Addendum #1**October 6, 2025****Warrenton & Hammond Pile Replacement Projects****Pile Project Q&A**

Figure 3A: Aerial Photograph (Warrenton Marina)
 Warrenton and Hammond Marinas Piling Replacement
 (Google Earth 2024)

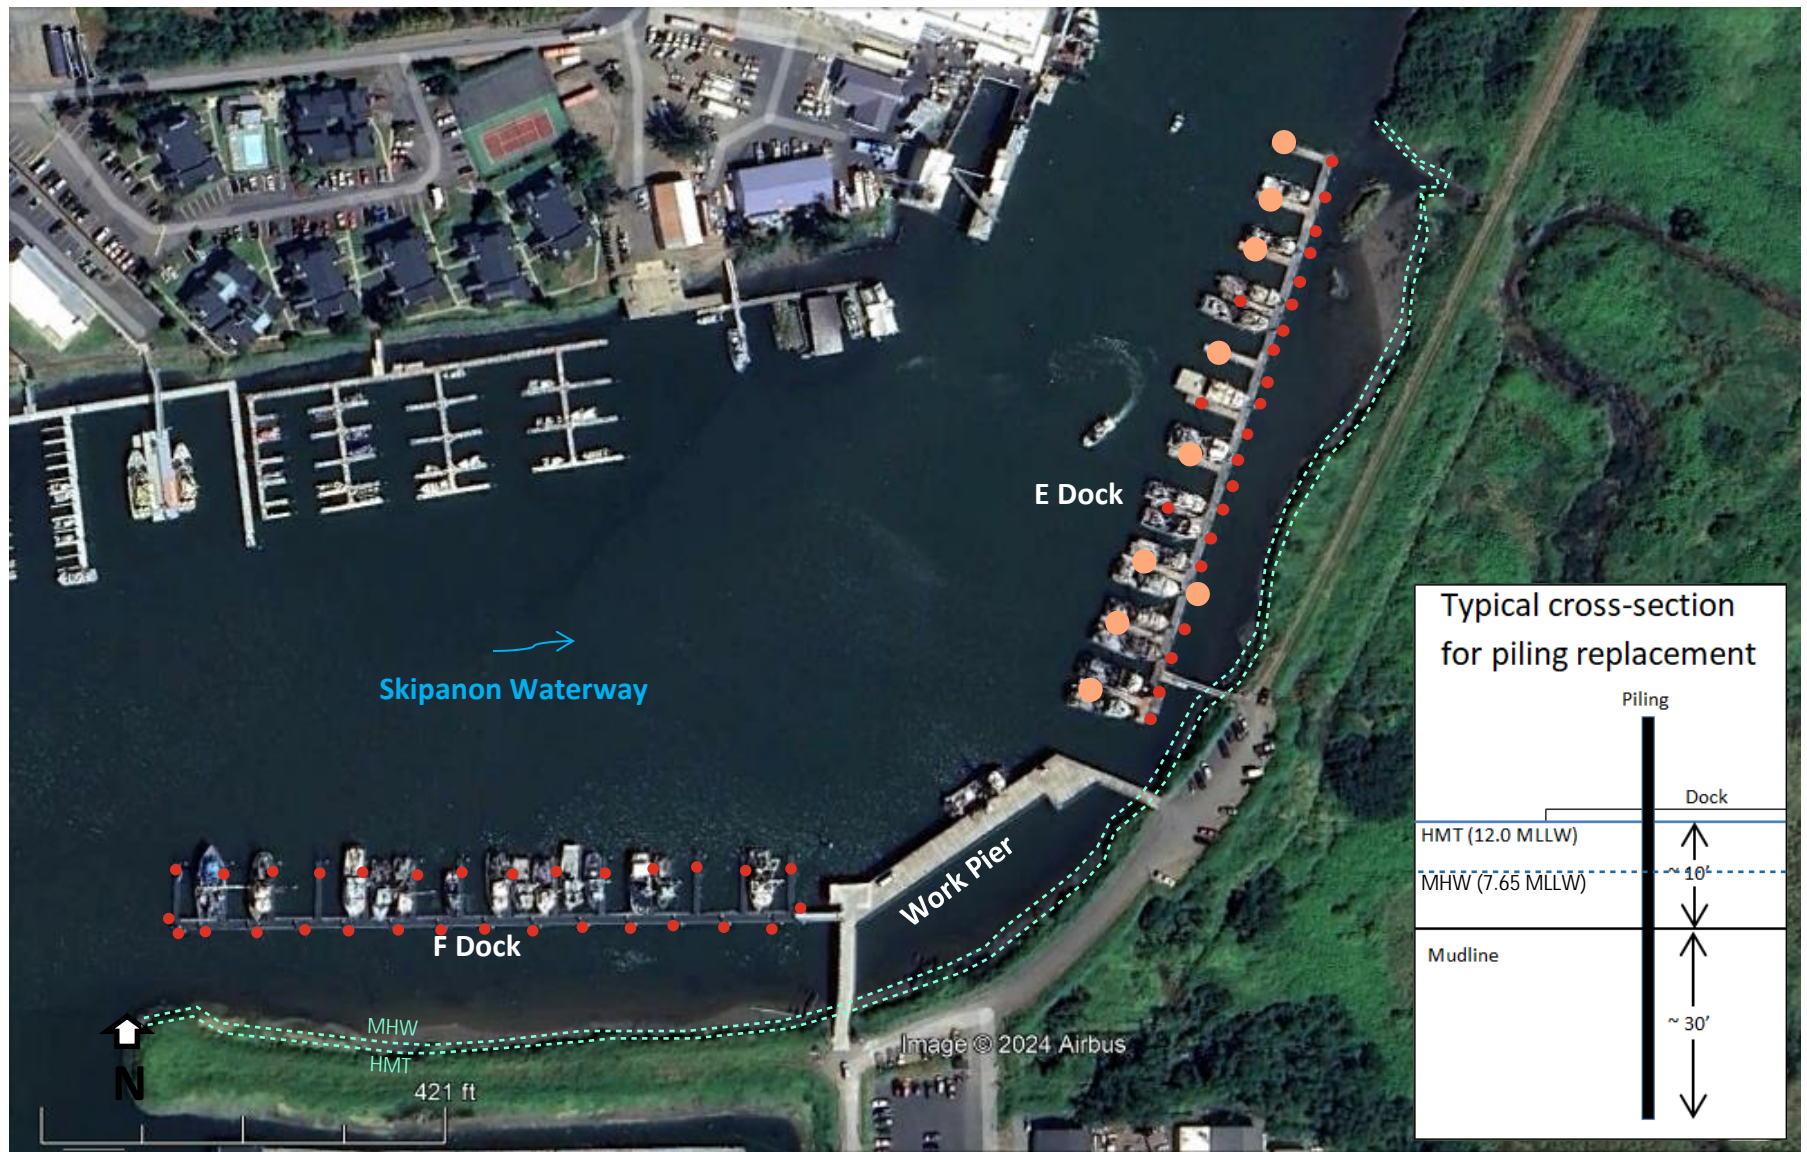
- Around 30'
7. Can you provide a map showing the locations of the piles to be replaced at each marina? Attached.
8. Is there any bathymetry data available for the two marinas?

● Pilings proposed for replacement (158)
